Access Compliance Report
Public Rights-of-Way
(Curb Ramps)

Intersection ID: 14183	Main Street: WEST_BV	Cross Street: OLD_STEELE_CREEK_RD	Location:	SW
ADA ID: 10473745F99B	Ramp Type: ParaDiag	Initial Pass/Fail: Pass	Overall Compliance: No	Severity Score: 10.25

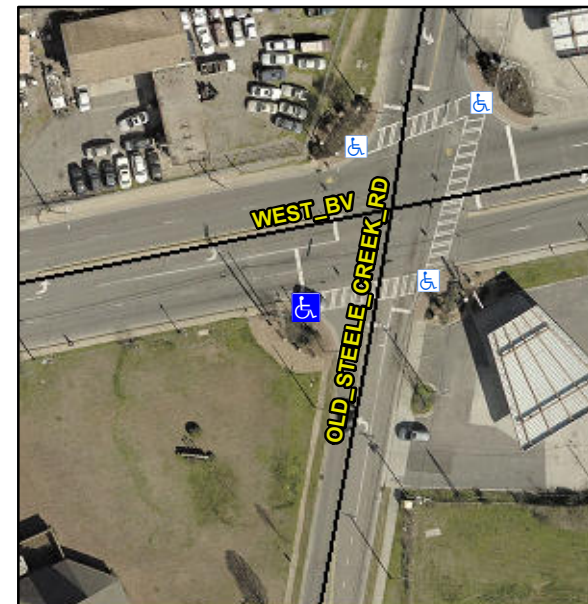
Surveyor Notes:

RAMP PAVERS

R304.5.3, R304.2.2-Perp, R304.3.2-Para, R305

Compliance	Description	Data	Compliance	Description	Data
N/A	Ramp Length LT (in)	38.0	N/A	Ramp Length RT (in)	48.0
Yes	Ramp Width LT (in)	58.0	Yes	Ramp Width RT (in)	59.0
Yes	Ramp Slope LT (%)	6.0	Yes	Ramp Slope RT (%)	7.5
No	Ramp XSlope LT (%)	2.4	No	Ramp XSlope RT (%)	2.7
Yes	Landing Length (in)	126.0	No	DWS Provided?	No
Yes	Landing Width (in)	60.0	N/A	DWS Contrast?	No
No	Landing Slope (%)	2.9	N/A	DWS Length (in)	N/A
Yes	Landing X Slope (%)	0.5	N/A	DWS Full Width?	No
N/A	Landing Curb? (Y/N)	No	N/A	DWS Offset (in)	N/A
N/A	Shared Landing?	No			
Yes	Gutter Ponding?	No	Yes	Gutter Slope (%)	1.7
Yes	Gutter Lip Ht (in)	0.0	Yes	Gutter X Slope (%)	0.3
N/A	Painted X Walk1?	Yes	N/A	Painted X Walk2?	No
	X Walk 1 Direction	To E		X Walk 2 Direction	To N
N/A	X Walk 1 Width (in)	105.0	N/A	X Walk 2 Width (in)	N/A
	X Walk 1 Slope (%)	0.7		X Walk 2 Slope (%)	1.3
	X Walk 1 X Slope (%)	1.2		X Walk 2 X Slope (%)	0.1
Yes	Ramp inside XWalk1?	Yes	N/A	Ramp inside XWalk2?	N/A

Remove & Replace Curb Ramp With Two New Directional Ramps or Equivalent.
